**Subject: Proposed Technical Changes  
Renewable Energy Approval (No. 2318-8Q6PXQ)  
Crosby Solar Project**

Northland Power Inc. is proposing to develop and operate a 10-megawatt (MW) solar photovoltaic facility located at 249 Little Rideau Lakes Road in the Township of Rideau Lakes, within the United Counties of Leeds and Grenville. This project is herein referred to as the “Crosby Solar Project” or the “Project”.

The Ministry of the Environment (MOE) issued a Renewable Energy Approval (REA) for the Project (No. 2318-8Q6PXQ) on January 20, 2012. Since issuance of the approval, Northland Power has conducted detailed engineering and is proposing revisions to the site plan for the facility, specifically the location of the access road and the placement of Project fencing within the original leased boundary for the Project.

Northland Power Inc. on behalf of  
 Northland Power Solar Crosby L.P.  
**Northland Power Solar  
 Crosby - Solar Energy Project**  
**Project Location Map**

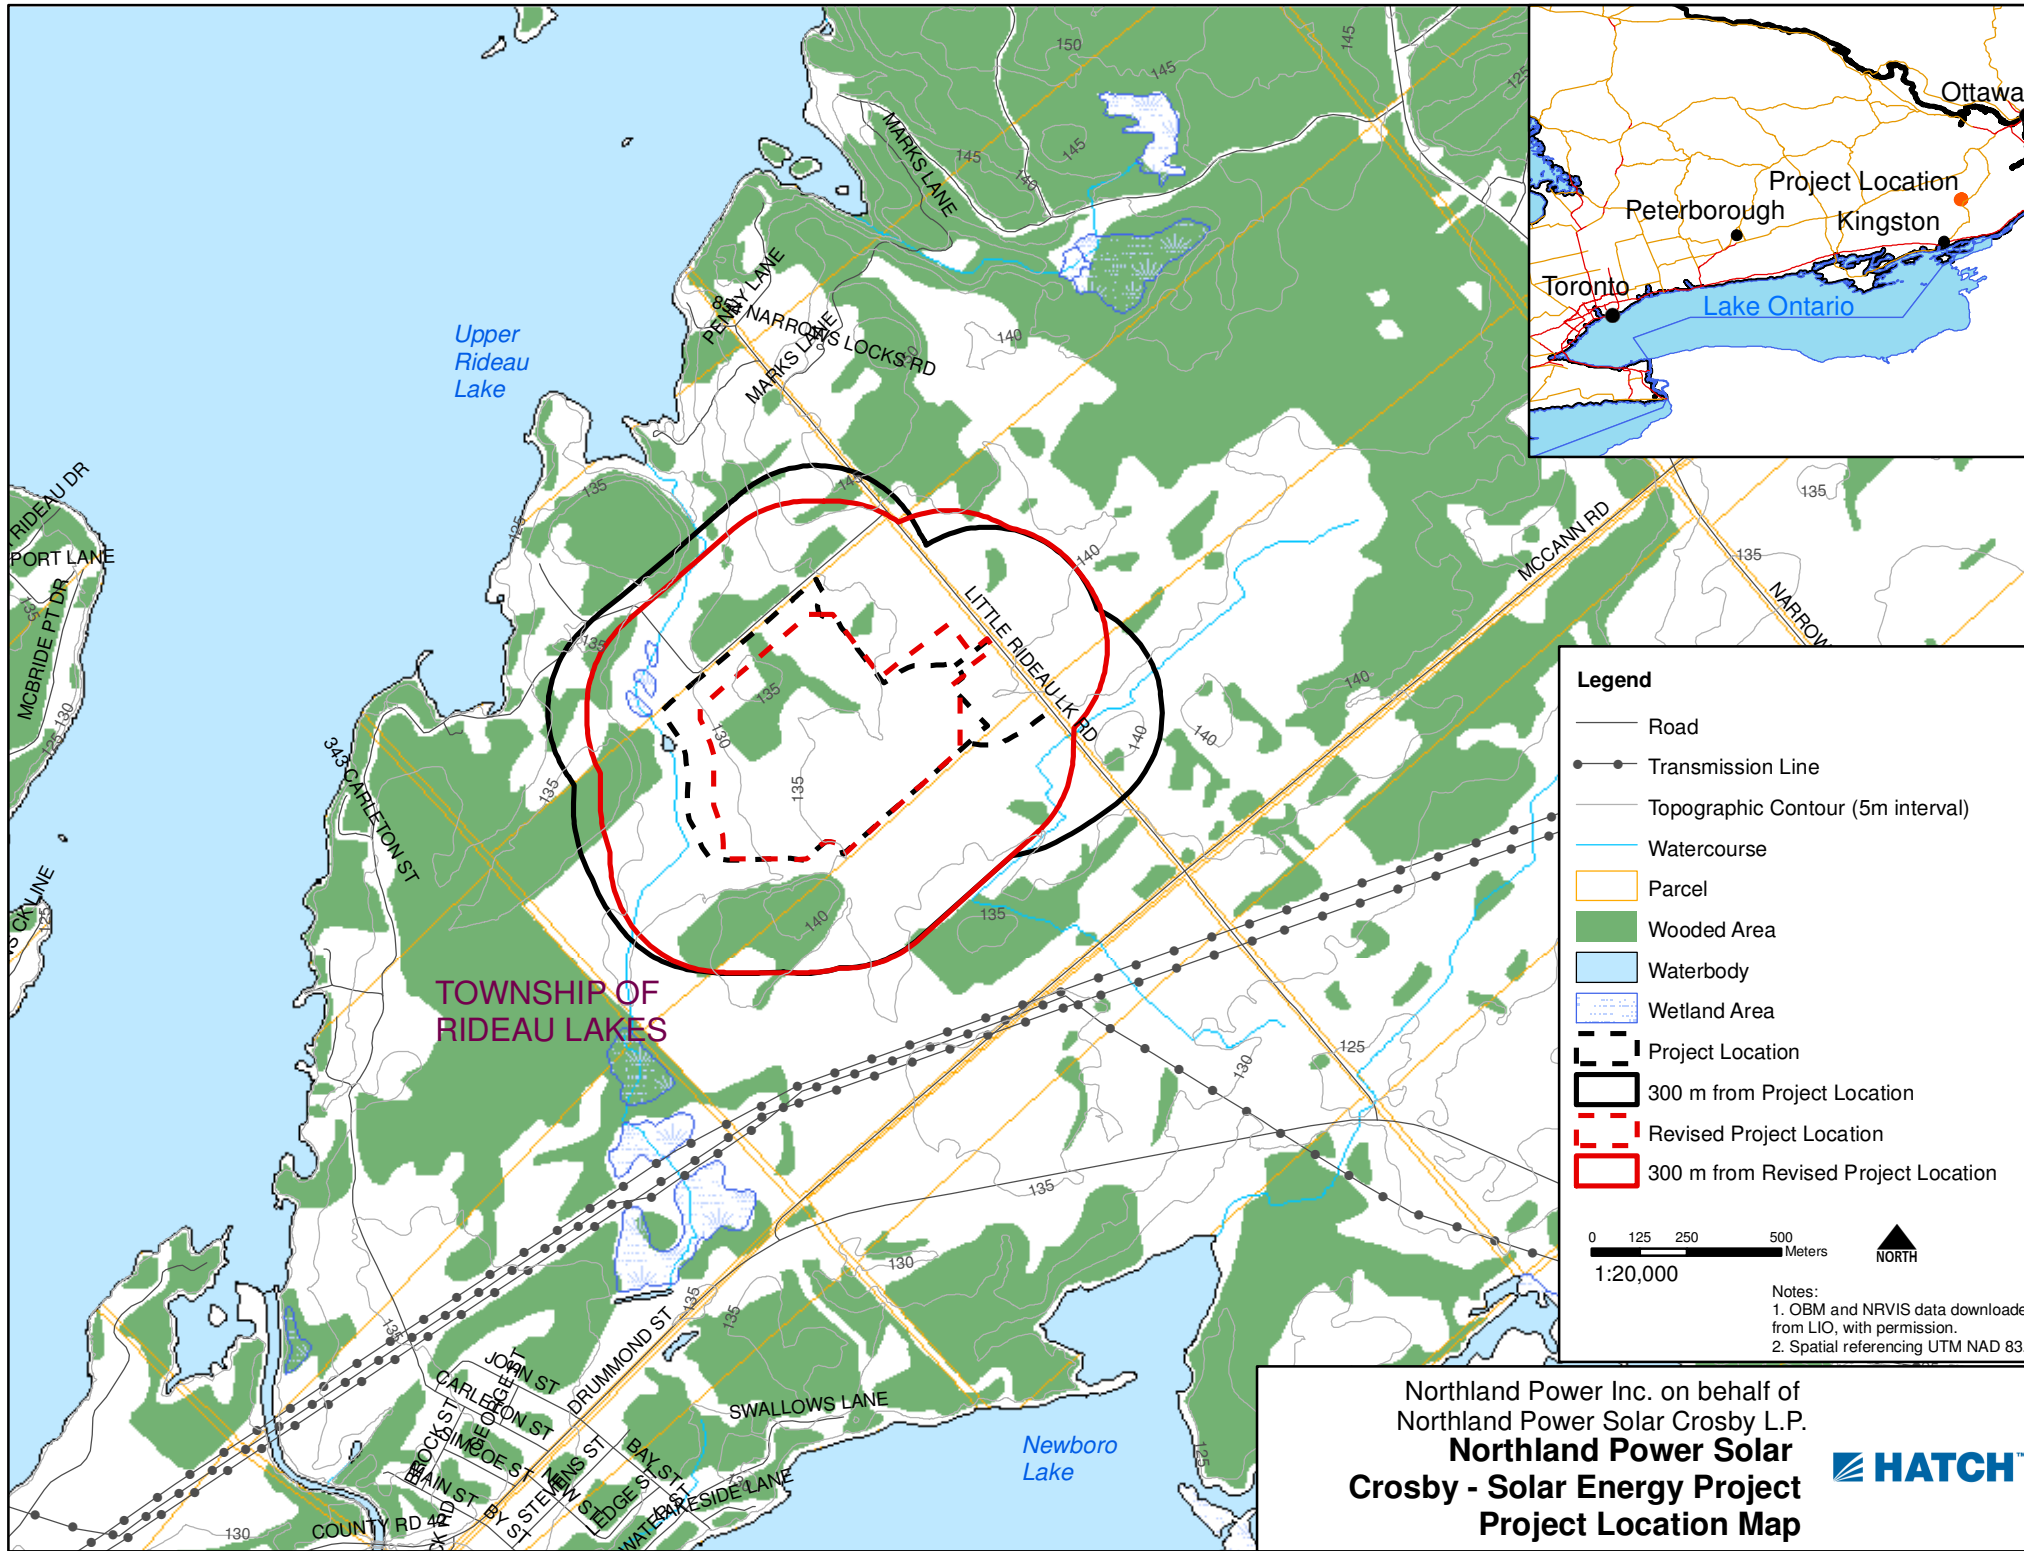
Page	Section	Original Text	Amended Text
4	2.5.1	A one-lane, 5-m wide access road will be constructed which will be of sufficient size for the transportation of equipment.	A one-lane, 7.6-m wide access road will be constructed which will be of sufficient size for the transportation of equipment.
12	n/a	Project Location Map	See attached revised Project Location Map (Attachment B).

This notice is provided to make you aware that Northland Power Solar Crosby L.P. is applying to the MOE for an amendment to the REA. This amendment is being made as the location of the fencing in the northeast corner of the Project has been changed outside of the original Project location, though within the leased boundary. As well, the location of the access road entrance to the Project location has been modified. These changes are shown in the attached figure. These changes are minor in nature and are not expected to have an impact on significant natural features or waterbodies.
